**MANDATORY SERVICE BULLETIN NO. DAC1-27-03 REV. 1**

SUPERSEDES DAC1-27-03 REV. 0

Type: DA 20-C1

ATA code: 2750.

Figure 1 - flap bellcrank.

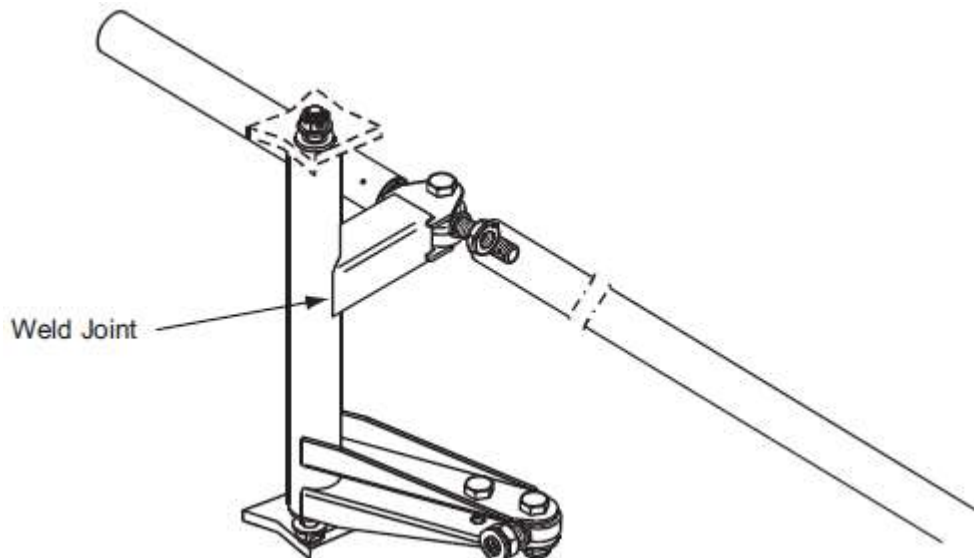
There have been two reported failures of the flap bellcrank (P/N 22-2750-03-00), one at 4500 TTSN and one at 7500 TTSN. This type of failure could result in the flaps being disconnected from the actuator (not asymmetrical) which could result in an unsafe condition for certain phases of flight. Pending further investigation, it is not known if this failure is the result of overload (e.g. flap deployment above  $V_{fe}$ ) or other causes, (e.g. fatigue, corrosion, defect). As a precaution, we are requesting all operators of DA 20 aircraft to inspect the bellcrank in accordance with this MSB.

1. Remove the center fuselage access panels.
2. Inspect the flap bellcrank, P/N 22-2750-03-00 around the weld connecting the top arm to the bellcrank tube. Look for cracks or any other damage in the area around the weld joint from both sides of the bellcrank. In particular, look thoroughly on the left hand side at the base of the vertical weld. Refer to Figure 1.
3. Move the flaps into the landing position in order to inspect fully around the weld joint.

4. If a crack or damage is found, replace the bellcrank with P/N 22-2750-04-00.
5. Report any findings to Diamond Aircraft Industries Inc. via e-mail at [custsupp@diamondair.com](mailto:custsupp@diamondair.com).
6. Re-install center fuselage access panels.
